# City of Portland Design Commission

## Design Advice Request

### SUMMARY MEMO

**Date:** March 14, 2019  
**To:** Richard Brett | LDA Architecture  
**From:** Grace Jeffreys, Design and Historic Resource Review  
503-823-7840 | [grace.jeffreys@portlandoregon.gov](mailto:grace.jeffreys@portlandoregon.gov)  
**Re:** EA 19-107328 DA – 1260 & 2201 NE Lloyd Center, Lloyd Center East  
Design Advice Request Commission Summary Memo – February 28, 2019

### **New Theater Building.**

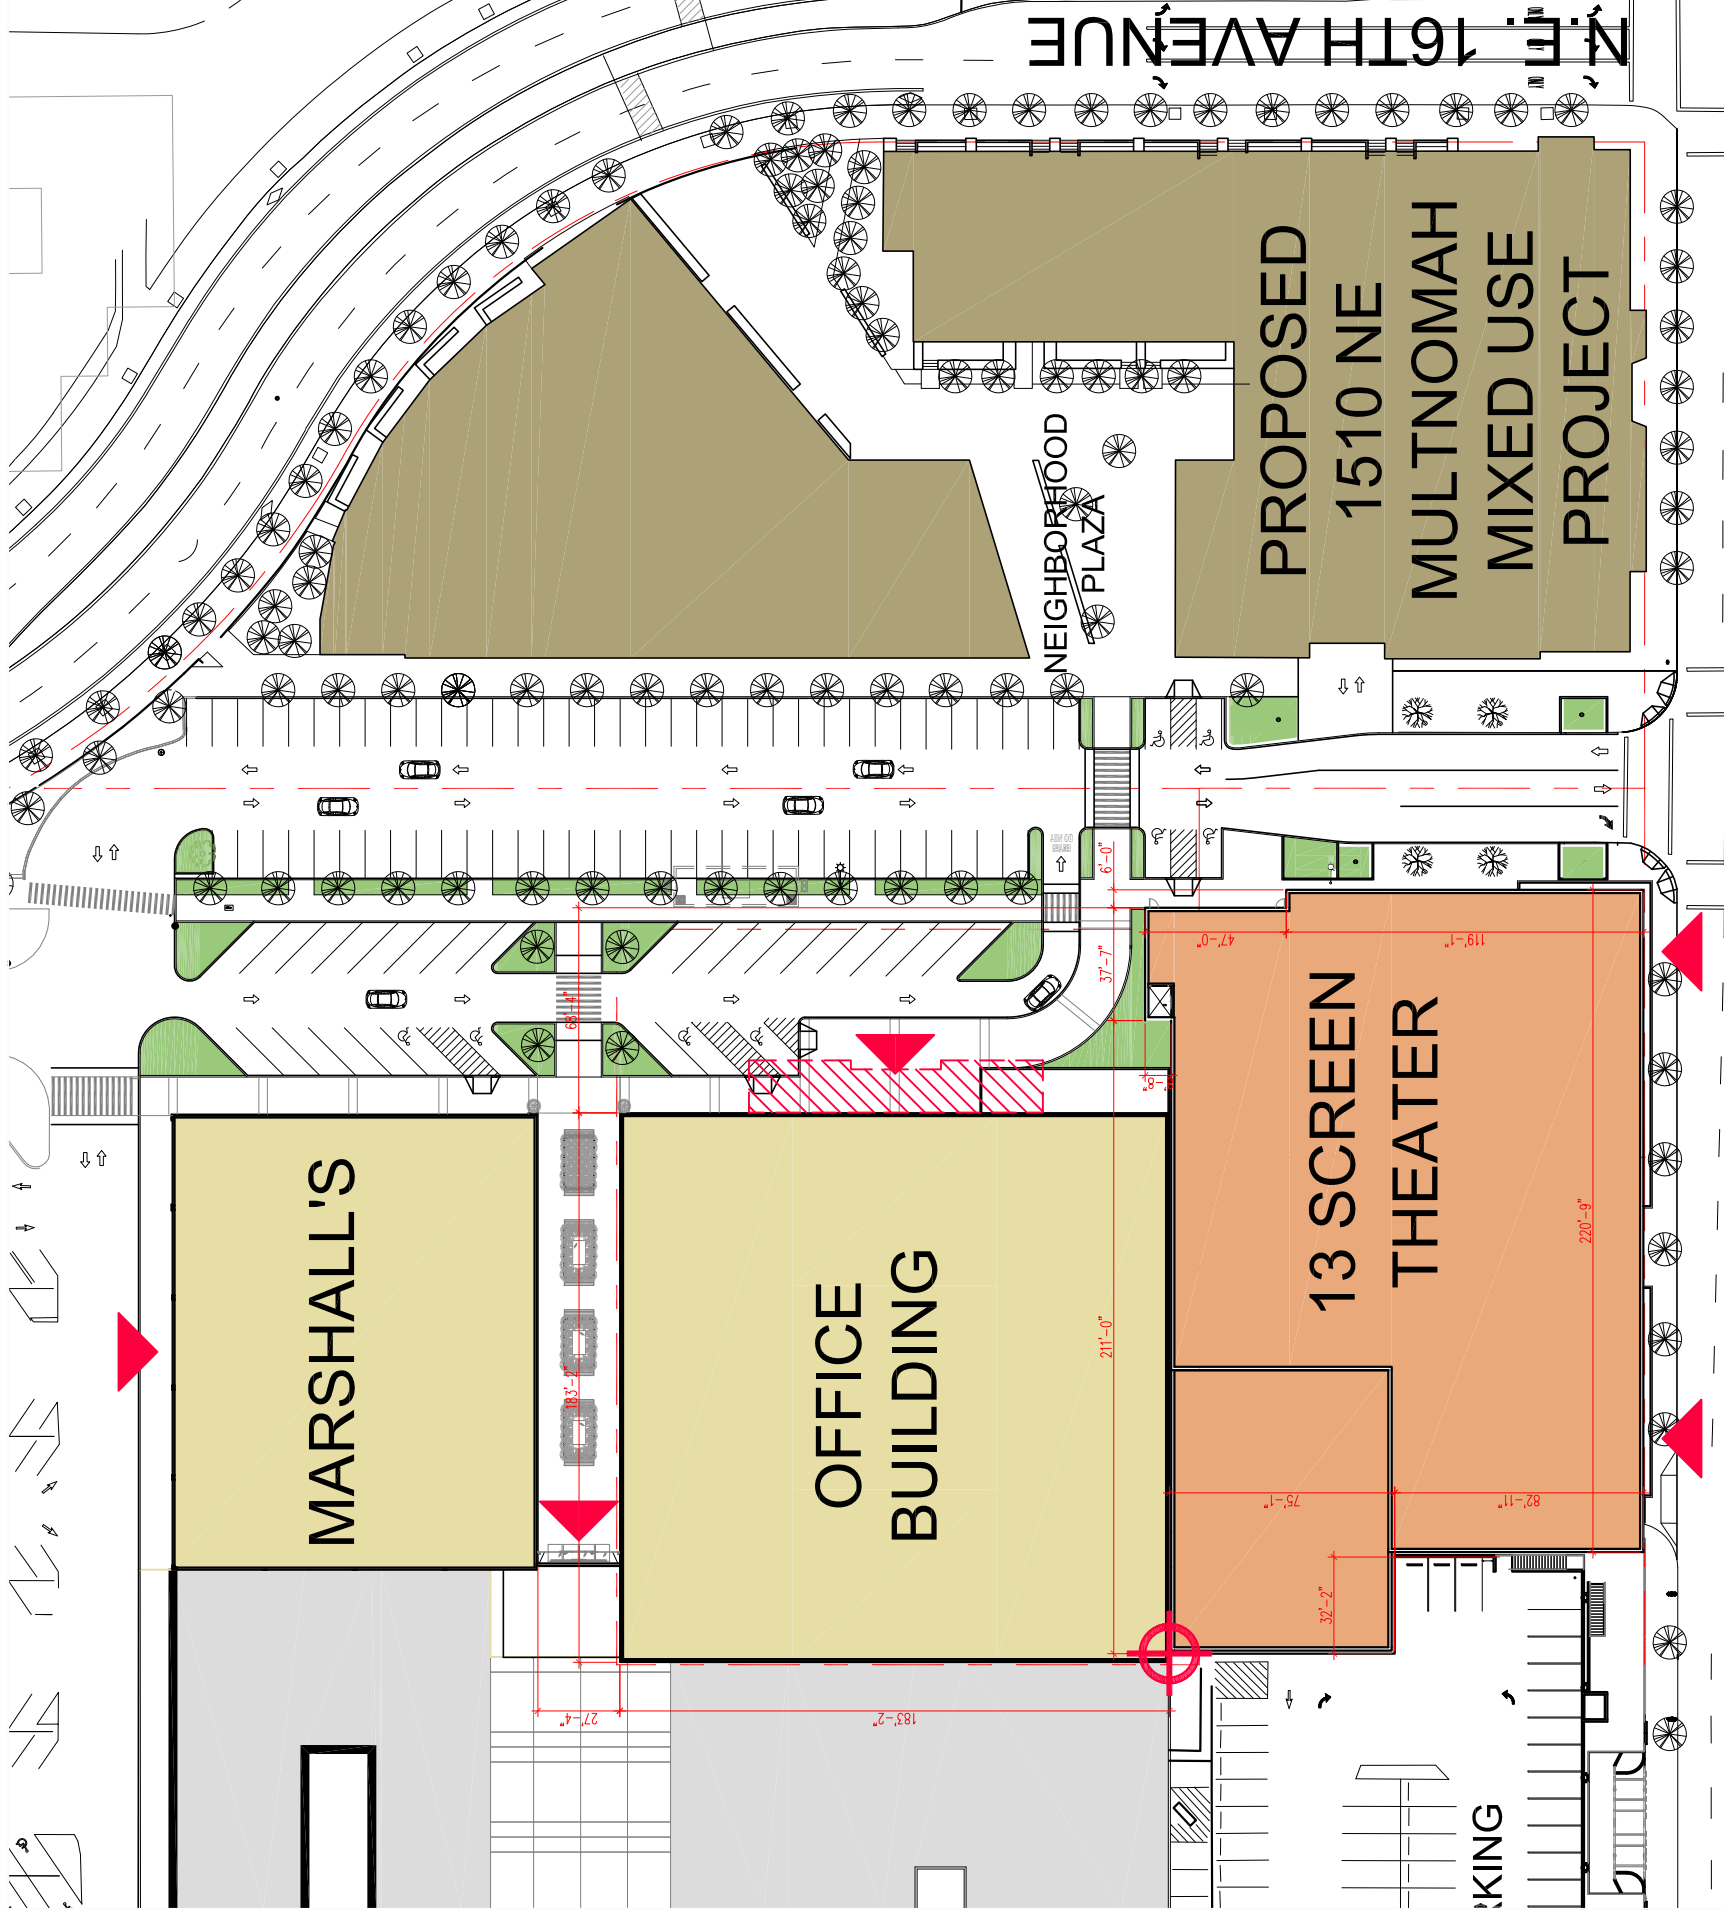
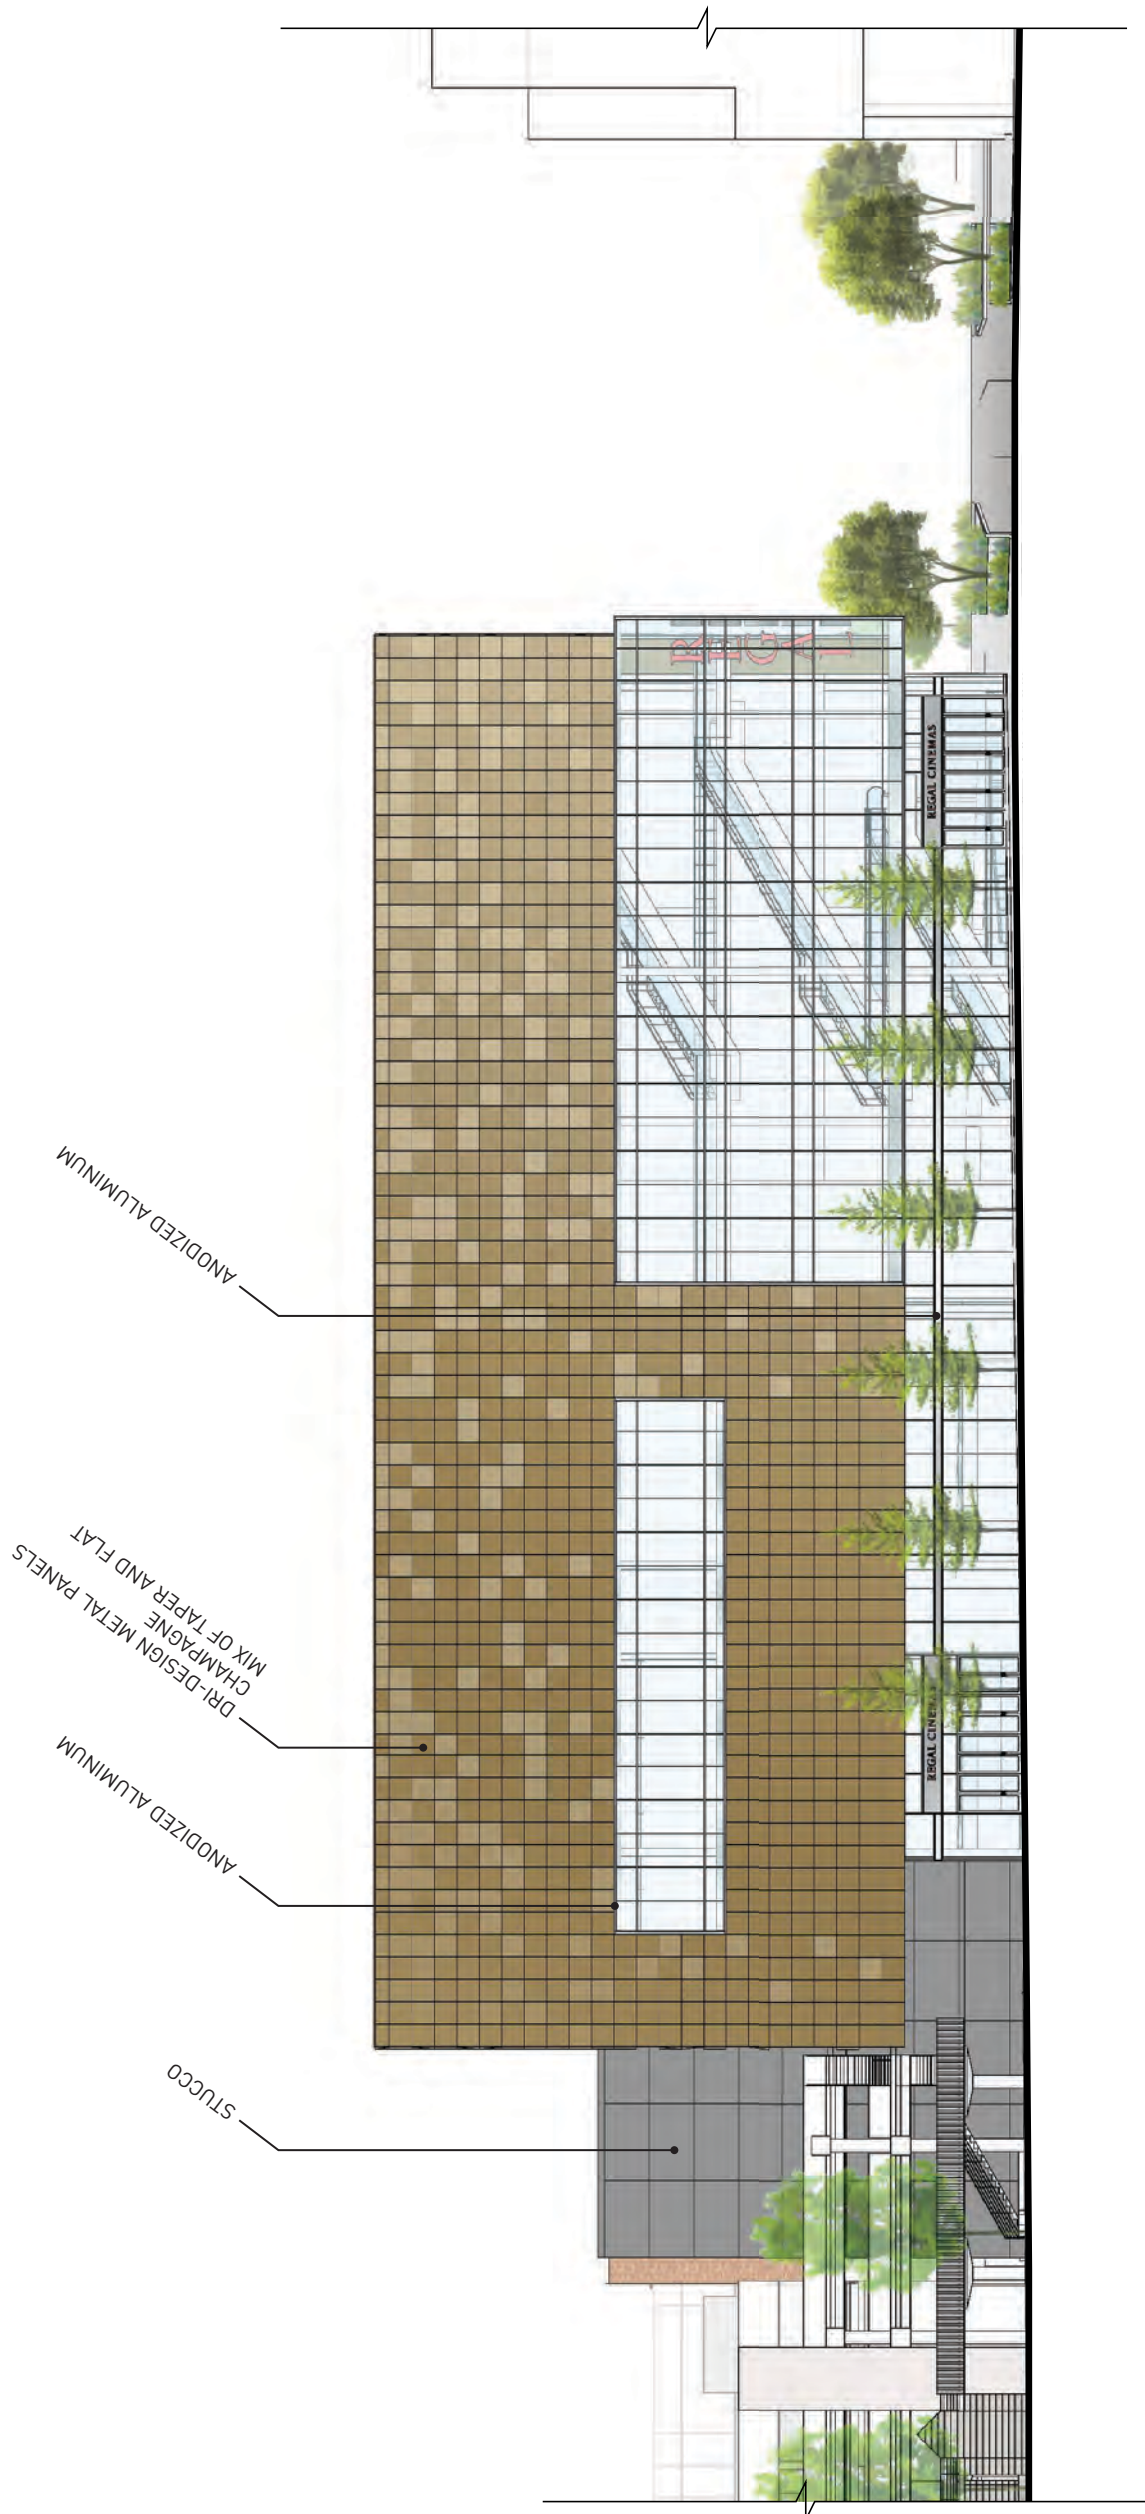
1. *Metal Cladding – Supportable.*
2. *Stucco – Split support. Consider using metal used on the rest of the building instead.*

1 Theater - West Elevation  
1" = 30'

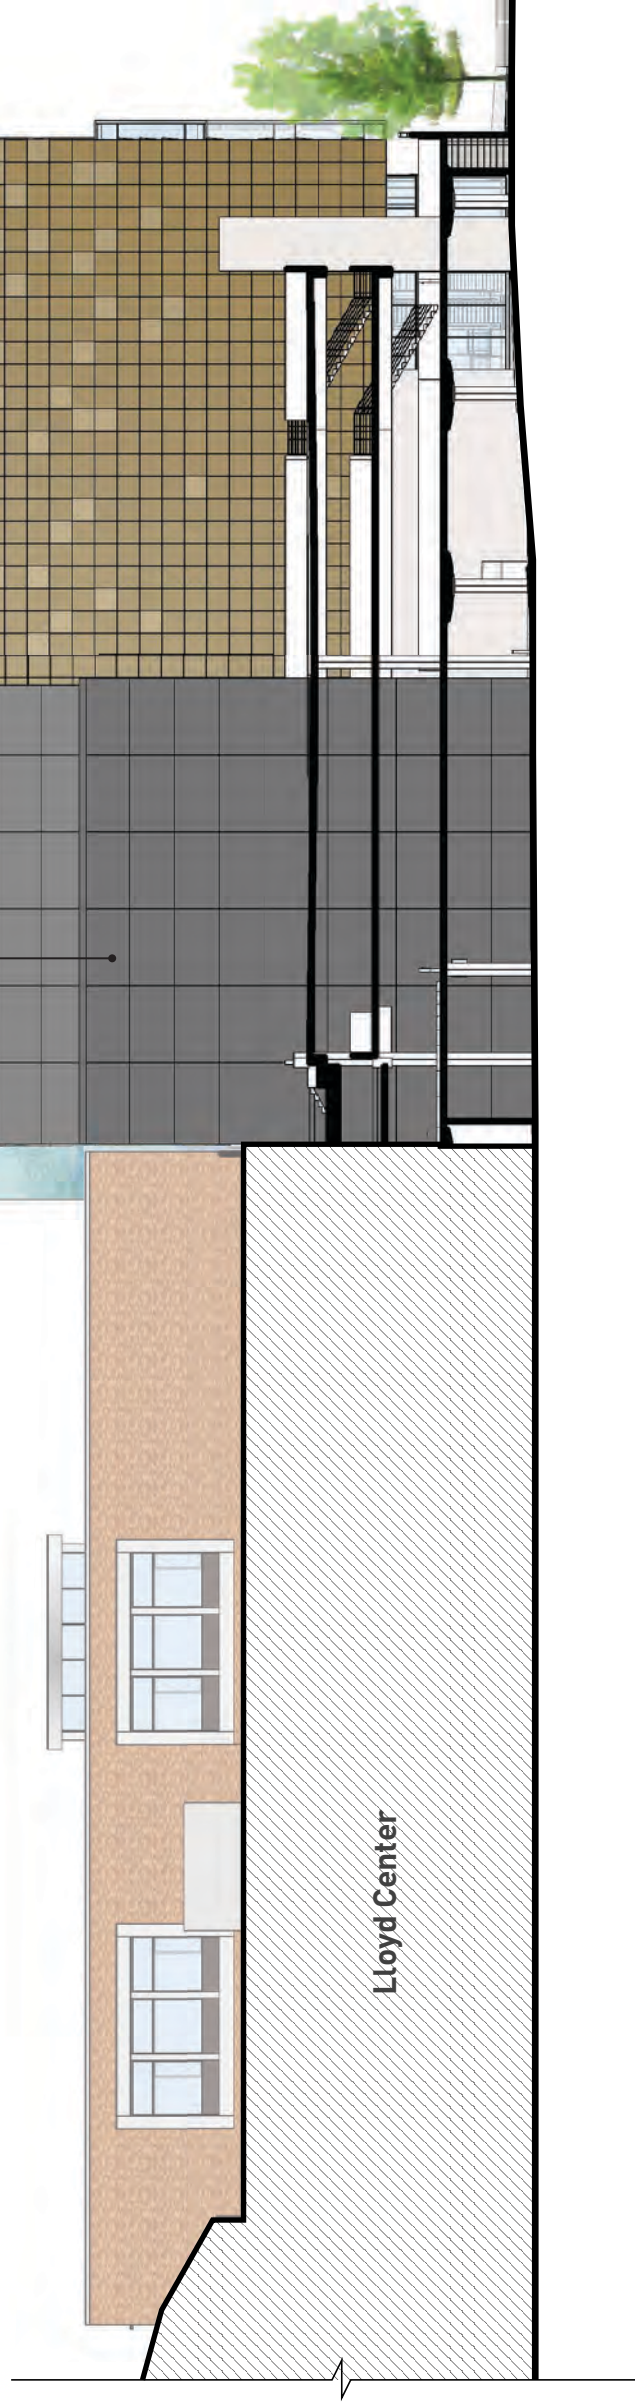
1. *Overall massing and height - Supportable.*
2. *Lobby locations and treatments - Supportable.*
3. *Oriels scale - Supportable.*
4. *Oriel design - Consider adding more dynamic movement like previous scheme, where oriels were angled.*
5. *West elevation – Consider adding an oriel presence to the west elevation.*
6. *Stair tower - Resolve the corner with an architectural rather than graphic solution. Vertical circulation generally should be located away from corners, and corners should be activated. Additionally, the mass may be better integrated into the Theater, as it currently competes with the Theater and the Anchor masses.*
7. *North elevation – Needs to better relate to the pedestrian areas to the north (Post hearing staff note - ground floor window requirements will apply to this elevation).*
8. *Public Art – If intending to use public art, start process with RACC early.*
